TECHNICAL NOTE

Wilthorpe, Barnsley

Assessment of Roundabout Access

GWB/14901/TN01 - 30 October 2014 Rev A

Drawing Title:
BARNSLEY COUNCIL
ROUNDABOUT OPTION

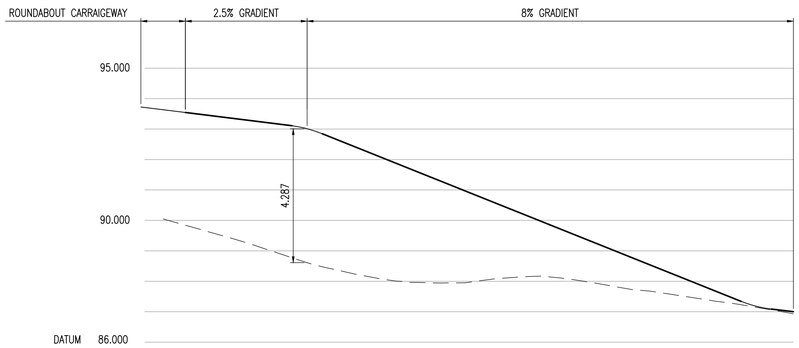
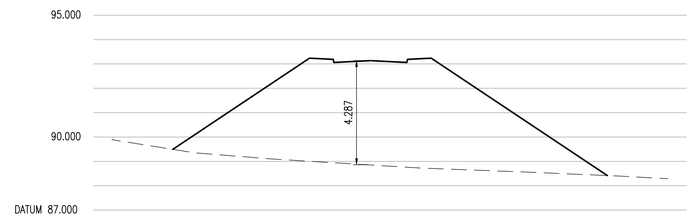
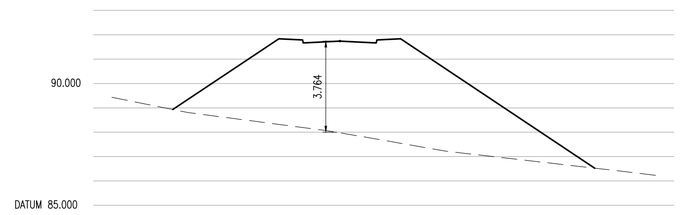
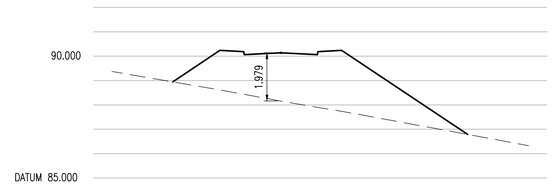
6. SCP have reviewed the draft design provided by Officers of Barnsley Council to Persimmon Homes. This includes for a very much larger central island and raises the following issues:

8. Introducing a roundabout at the proposed location alters the alignment of the A635. The result of this is that Wilthorpe Road is nearer to existing properties on Wilthorpe Farm Road and Wilthorpe Road itself.

11. The roundabout design has clear implications for the scheme layout as currently proposed. Persimmon Homes estimate that 10 – 15 plots will be lost as a result of the new roundabout proposed by Barnsley Council. This is either as a result of the roundabout and access road utilising land previously shown for new houses, or through the required change in levels to ensure the road meets maximum access road gradients of 1 in 12.

15. The more obvious of these works relates to the access road and provision of roundabout with associated earthworks and creation of earth retaining structures.

16. There is also the potential for the roundabout works to impact on the culvert of the adjacent beck, which runs under Wilthorpe Road. This has not been explored in detail.

18. The proposed roundabout extends beyond the site boundary onto Third Party Land which lies south side of the application boundary on land which is not within the control of Persimmon Homes.

20. The current scheme does not meet current design standards. However, it is accepted that the design is a draft layout and it may be possible to meet standards as a result of more detailed design work.

22. The size of the roundabout and the associated embankment would have a significant visual impact and would impact on the housing layout.

23. The cost of providing the roundabout alone is of the order of £350,000. This, associated with as yet unknown costs associated with the loss of plots, the potential for further engineering works and any claims under the Land Compensation Act could potentially make the site unviable.

24. The roundabout solution is unsustainable, provides far more capacity than is needed and has a far greater impact than necessary.

Drawing Title:
PROPOSED GHOST ISLAND RIGHT TURN

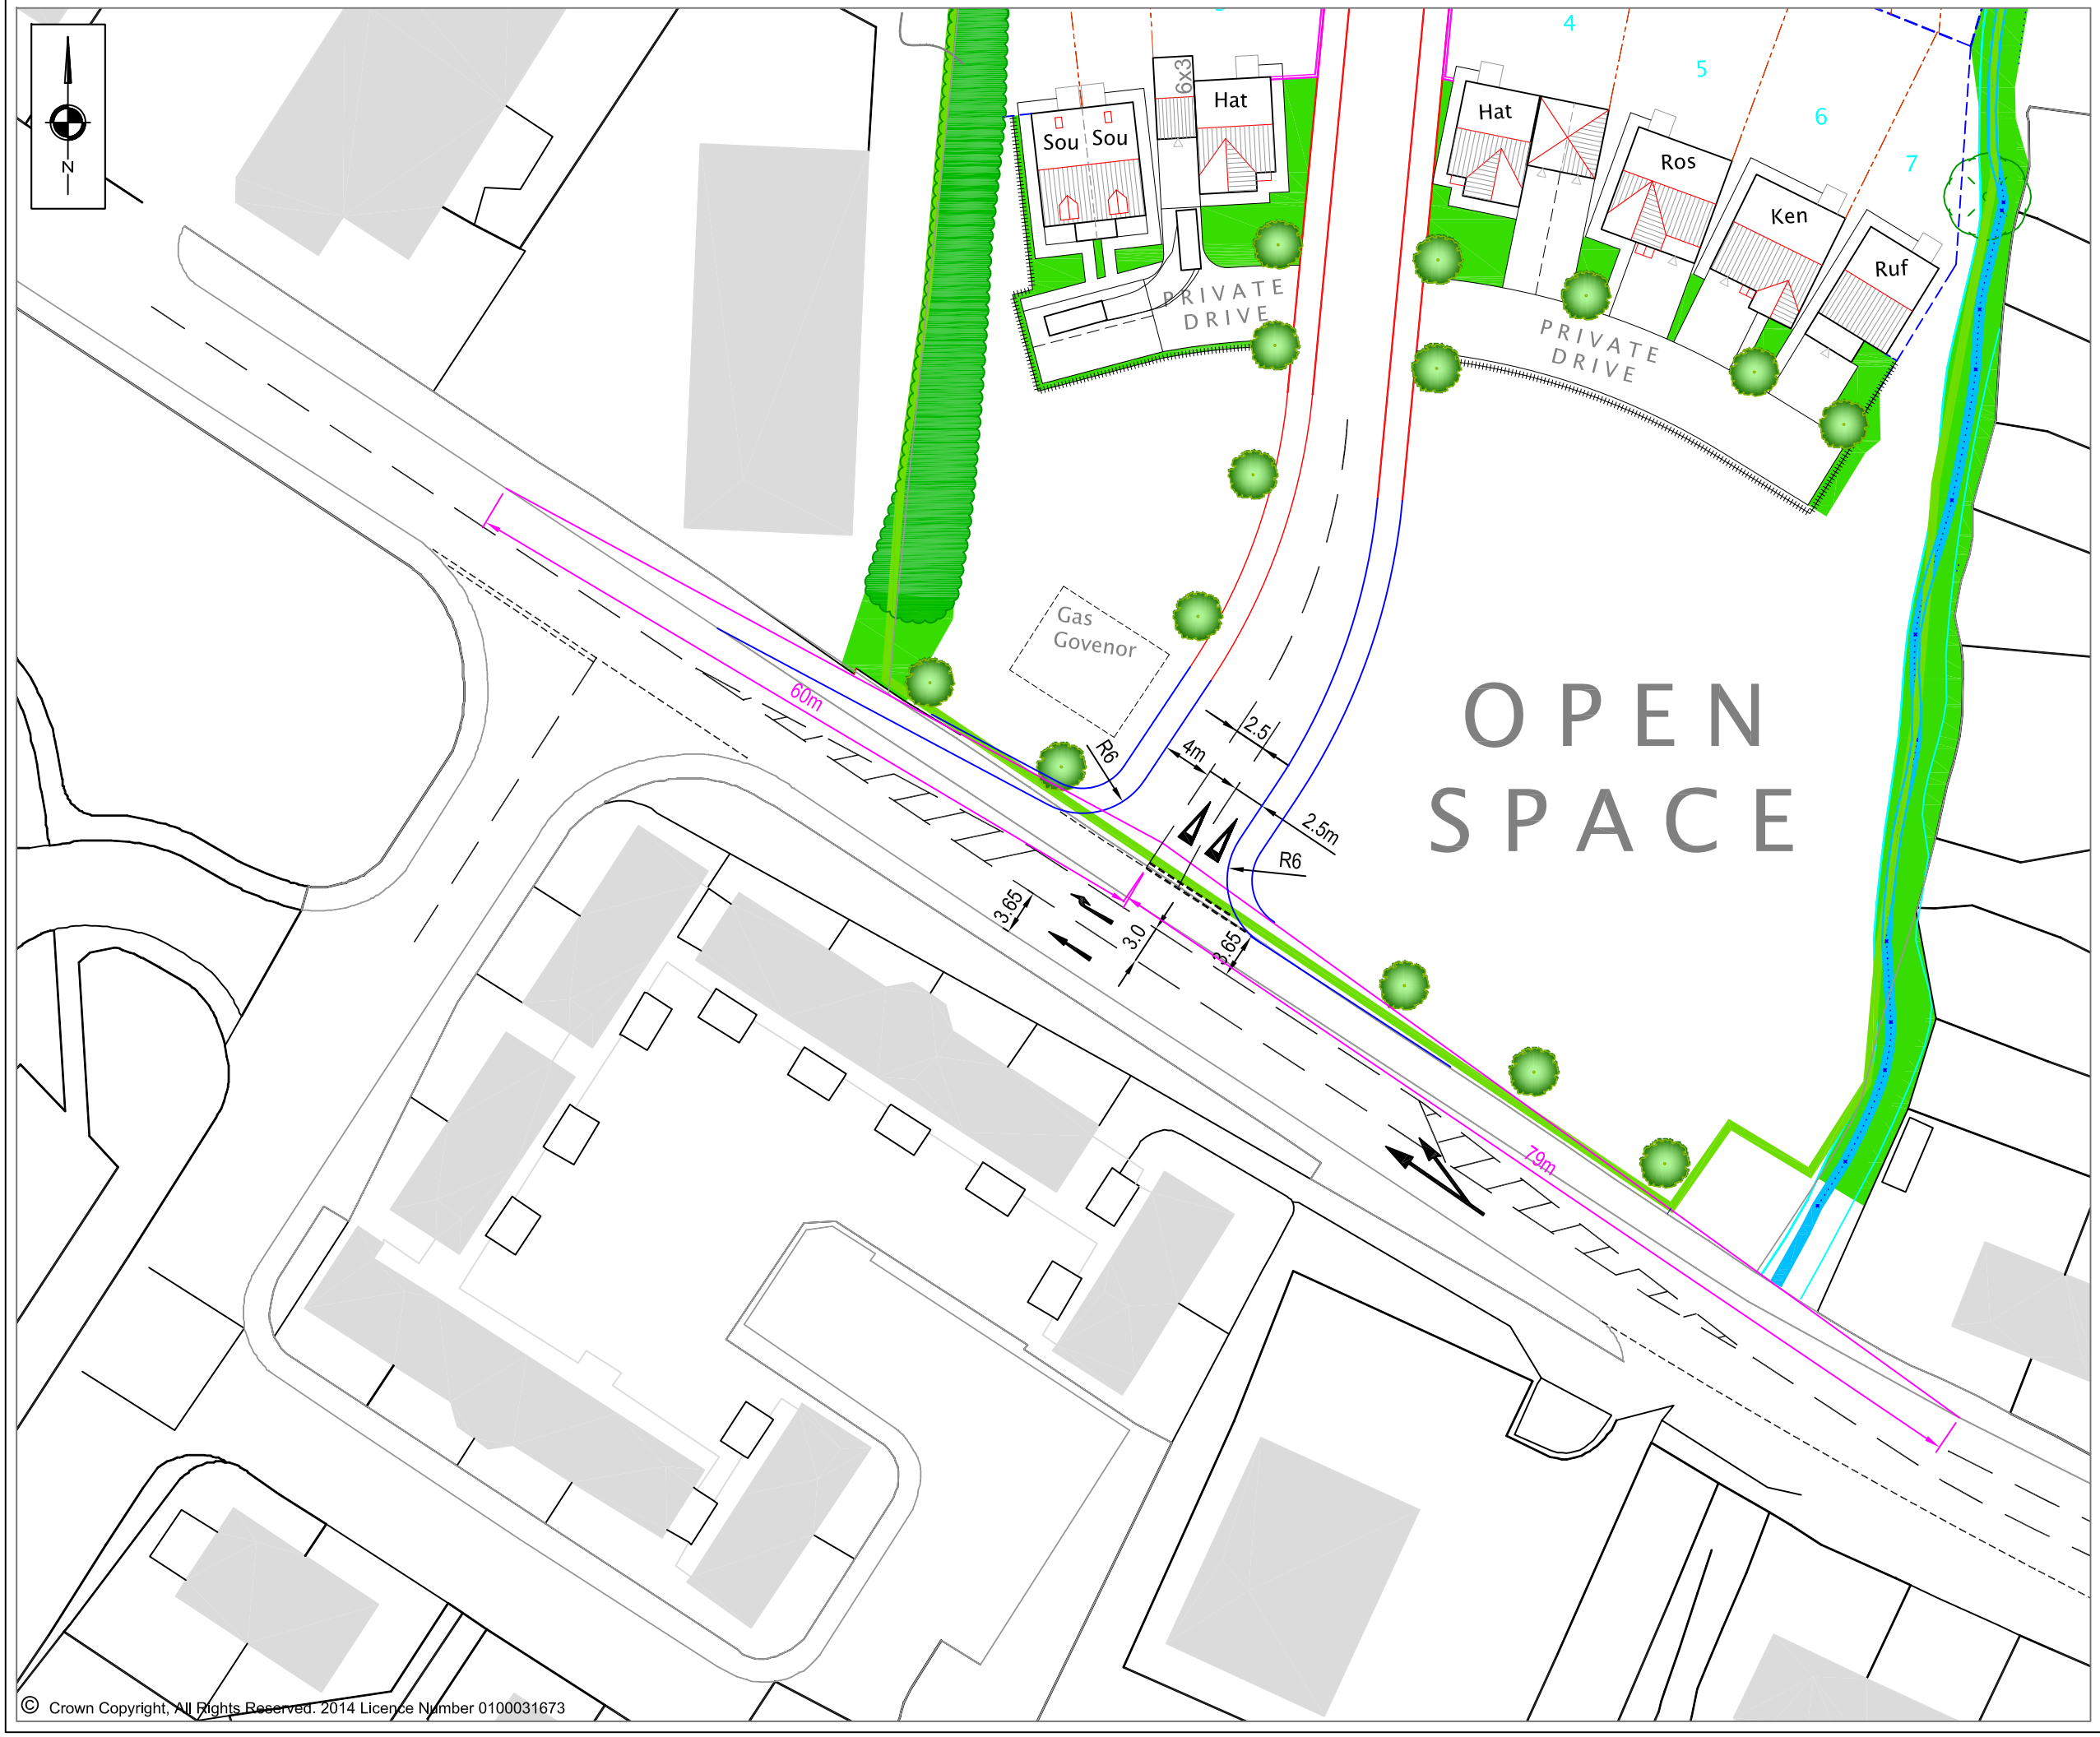
27. Whilst the original layout meets design standards and has considerable spare capacity, it is understood that there is some concern relating to the safety of right turners leaving the site and potential for queuing on exit during the morning and evening peak hours.

28. This issue has been addressed by an amended ghost island junction as shown at **Appendix 2**. This will include for the widening of the access road on the approach from the development to Wilthorpe Road to provide segregated lanes for exiting traffic. Hence vehicles waiting to turn 'right out' will not delay vehicles waiting to turn 'left out' and vice versa.

29. The improved ghost island junction accords with guidance, it has even more spare capacity than the original access proposals and would pass a Road Safety Audit.

33. Persimmon Homes propose that the concerns of Members can be addressed through the provision of an additional lane for traffic leaving the site i.e. segregated lanes for left and right turning traffic. This is shown on drawing at **Appendix 2**.
